WHC-99/CONF.205/INF.3C

Information Document: Assessment of the Jabiluka Project: Report of the Supervising
Scientist to the World Heritage Committee

Assessment of the Jabiluka Project

Report of the Supervising Scientist

Figure 3.3.1 Comparison of average monthly storage evaporation estimates and point potential and areal potential evapotranspiration rates

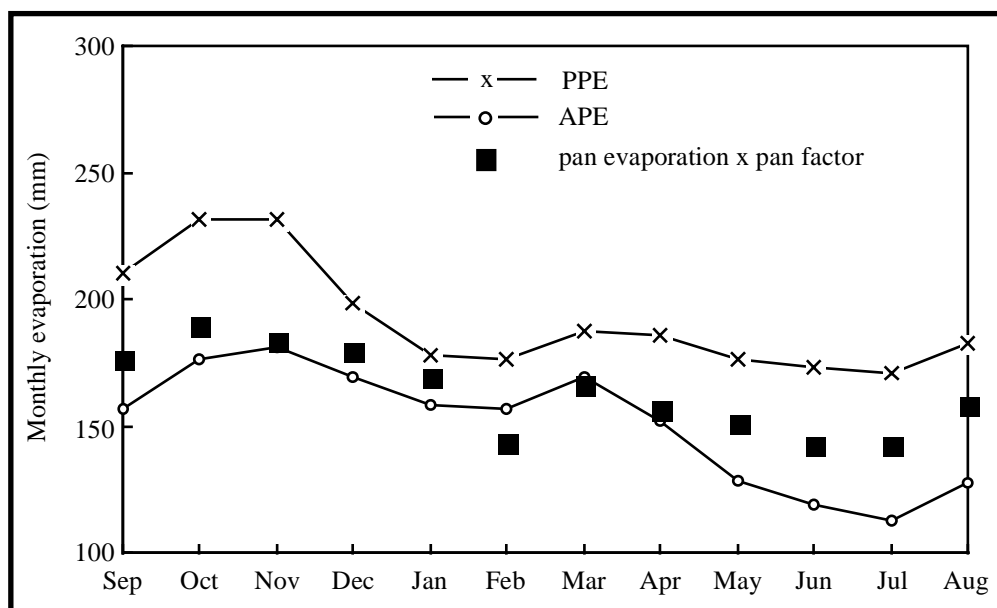
Wasson et al (1998) note the use by ERA of two simple seasonal factors to estimate pond evaporation from pan measurements; 0.6 in the Dry season (May–October) and 0.75 in the Wet season (November–April). They assert that there is a need to check these factors by appropriate modelling that incorporates existing solar radiation data and that the extensive evaporation study conducted at Manton Dam, south of Darwin, needs to be taken into account.

The approach outlined above was adopted by ERA in the draft EIS in 1996 but Wasson et al (1998) seem to have been unaware that ERA adopted a more sophisticated approach in the PER for the Jabiluka Mill Alternative. It was the proposal for the Jabiluka Mill Alternative, presented in 1998, which was the subject of investigations conducted by the Mission of the World Heritage Committee to Kakadu. ERA outlined in Appendix B1 of the PER the procedure adopted in estimating evaporation from the retention pond. Pan factors for each month of the year were adopted following a review of all existing evaporation data relevant to the region by CSIRO (Hatton 1997). The conclusion of Hatton (1997) was that, with the exception of the two months of April and October, the pan factors derived by the Supervising Scientist (Vardavas 1987) should be used in all water balance calculations.

Figure 3.3.1 shows the evaporation rates calculated using the Vardavas (1987) pan coefficients and these are compared to the APE and PPE values. All of the Vardavas calculations are in agreement with the seasonal pattern of the APE and the PPE. For February and March, the estimated storage evaporation rates are lower than the APE and Chiew and Wang (1999) concluded that this could be due to errors in the recorded pan evaporation (because of the difficulty in accurately estimating pan evaporation when rainfall is high) or errors in the APE estimates. The overall conclusion was, however, that the best estimates of pond evaporation for Jabiluka would be obtained by using the results of Vardavas (1987).

Figure 3.3.2 Relationship between evaporation and rainfall at Jabiru for the months of January, February and March

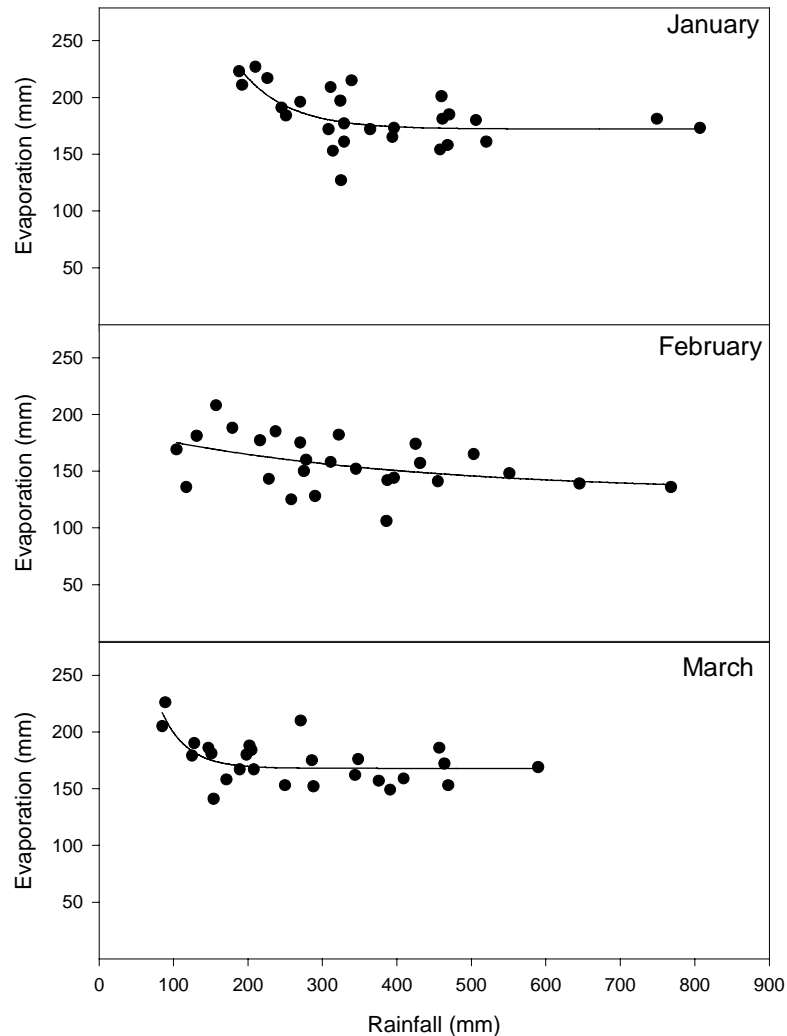
Wasson et al (1998) state that the principal source of error in the evaporation calculations of ERA arises from neglect of the inverse relationship between evaporation and rainfall which arises because solar radiation is lower on cloudy days than on sunny days. They suggest that the adoption of long-term mean values for the pan factors will result in a significant over-estimate of evaporation in very wet months and that this effect could exceed 10% during very wet years.

Chiew and Wang (1999) investigated the significance of the inverse relationship between evaporation and rainfall using data from a number of meteorological stations in the north of the Northern Territory including Jabiru, Maningrida, Middle Point and Darwin. They found that a linear inverse relationship was statistically significant for both the annual data and the quarterly data at each station and that it was most significant at Jabiru. They concluded that this effect should be taken into account in their modelling of the water management system at Jabiluka and they evaluated the significance of the effect on the required pond volume. The conclusion reached was that the retention pond volume would need to be increased by about 3% as a result of both the inverse relationship and interannual variability in evaporation.

There is, however, evidence that even this small effect is an over-estimate because, during the principal months of the Wet season (December to March), cloud cover is often extensive even when there is no rainfall. As a result, the relationship between evaporation and rainfall during any given month will not be linear but evaporation will tend towards a constant lower value at higher rainfall values. This effect is clearly illustrated in figure 3.3.2 where evaporation at Jabiru is plotted against rainfall for the principal Wet season months of January, February and March. The line through the data in each case is of the form

Figure 3.4.1 Variation of saturated vapour pressure (upper graph) and absolute humidity (lower graph) with temperature at atmospheric pressure $P=100\text{kPa}$

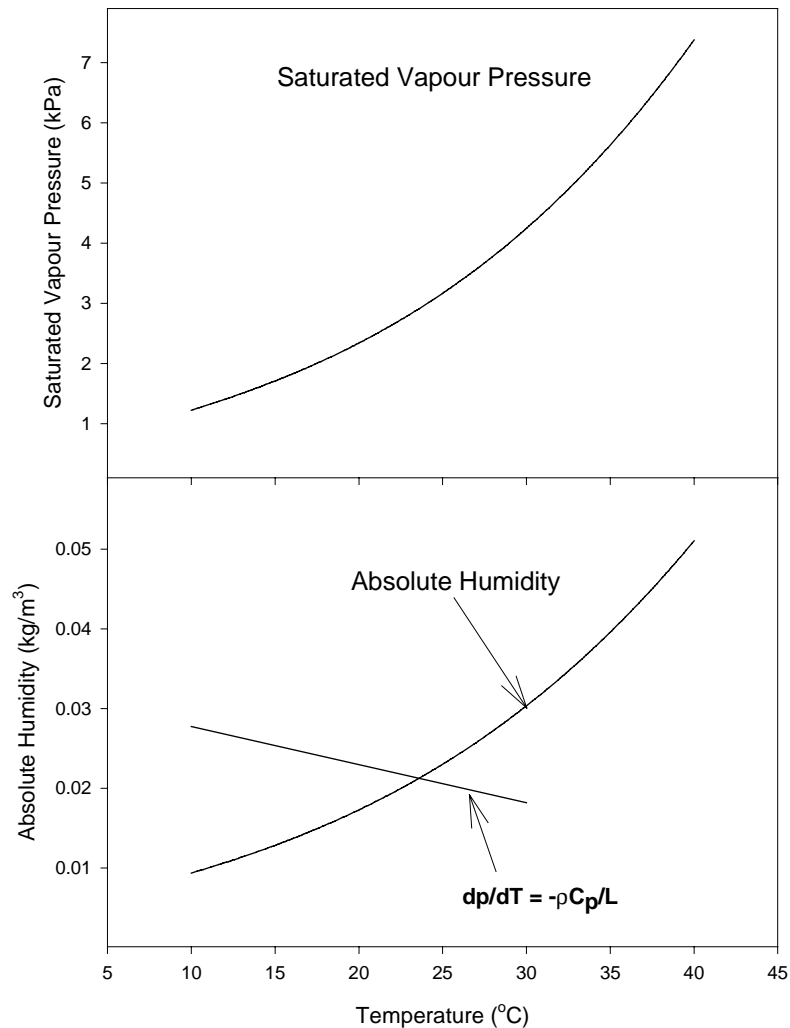
where Δp is the change in humidity, L is the latent heat of vaporisation, ρ is the density of air and C_p is the specific heat of air. Using $L = 2.43 \cdot 10^6 \text{ J/kg}$ (Kaye & Laby 1978, p 235), $\rho = 1.149 \text{ kg/m}^3$ (Kaye & Laby 1978, p 18) and $C_p = 1010 \text{ J/kg}^\circ\text{C}$ (CRC 1995, p 6-1), the decrease in temperature resulting from the vaporisation of the water would be 16°C . As can be seen from figure 3.4.1, the absolute humidity (ie fully saturated) at 14°C is about 0.012 kg/m^3 , a figure considerably less than the initial vapour density. Hence, the target evaporation figure cannot be achieved.

For 60% relative humidity, $p_0 = 0.0182(\text{kg/m}^3)$ at $T_0 = 30^\circ\text{C}$. This line is shown in figure 3.4.1. It intercepts the graph of absolute humidity at about 23.6°C which, as proposed by Wasson et al (1998), is the wet bulb temperature (estimated as 23.8°C from the data in CRC (1995) p15–22). At this temperature the absolute humidity is $0.0213 (\text{kg/m}^3)$. Thus the maximum quantity of water that can be evaporated is

$$p = 0.0213 - 0.0182 = 0.0031(\text{kg} / \text{m}^3).$$

This value is about 40% of the design value presented in Appendix J of the draft EIS.

These observations, however, do not imply that a major error exists in the proposal put forward for water management at the Jabiluka mine. If the latent heat of evaporation were to be supplied (for example, by standard humidifiers) there would be no need to take the above drop in temperature into account and the volume of water that could be evaporated would remain that estimated in the EIS and the PER. The Supervising Scientist consulted the engineer who advised ERA on this issue (Mr Douglas Rudd, Kinhill Pty Ltd) who advised that the calculations were provided to indicate the capacity of the ventilation system to dispose of additional water through evaporation. It was recognised that energy input via heaters, hot air blowers or staged misting/humidifiers would be required to achieve the full indicated disposal volume. These issues were, however, matters to be dealt with at the detailed design stage of the project when the potential of this method of water disposal could be evaluated (ie a cost benefit analysis) in a comparison with other methods such as increasing the area of the retention pond.

The area of the retention pond would need to rise from 9 ha to approximately 13 ha to provide the required evaporative capacity if no evaporation occurs in the ventilation shafts. This area is small compared to the total area of retention and tailings ponds proposed in the original JMA proposal and is only 2% of the disturbed area at the nearby Ranger mine. The environmental impact arising from such an increase, should it need to be part of the project, is, therefore, not considered to be significant.

Figure 5.3.1 Probability of occurrence of excess water volumes in the Jabiluka Total Containment Zone over the life of the mine for the storage capacity specified by ERA

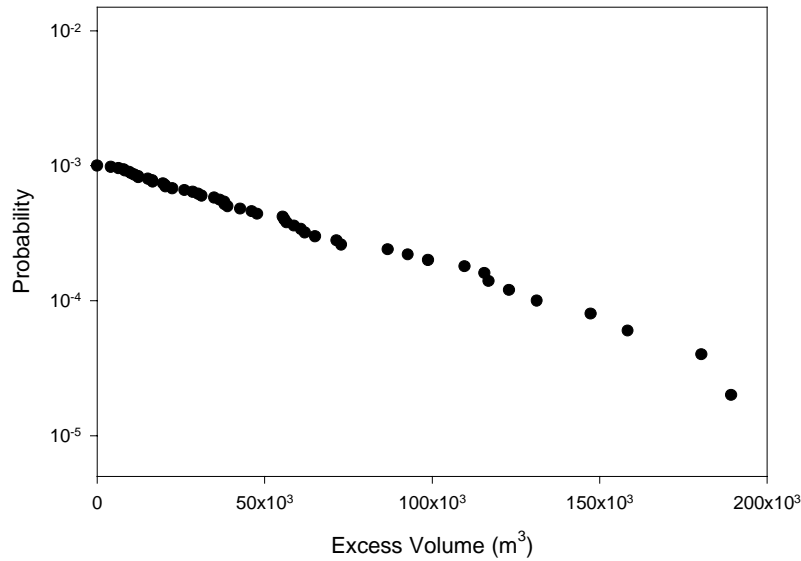
As stated in section 5.2.3, the storage capacity of the retention pond proposed by ERA in the PER was 810,000 m^3 . From the results of the Monte Carlo simulation methods shown in figure 5.2.1, the probability of the occurrence of water volumes in excess of the pond capacity can be derived. These results are shown in figure 5.3.1.
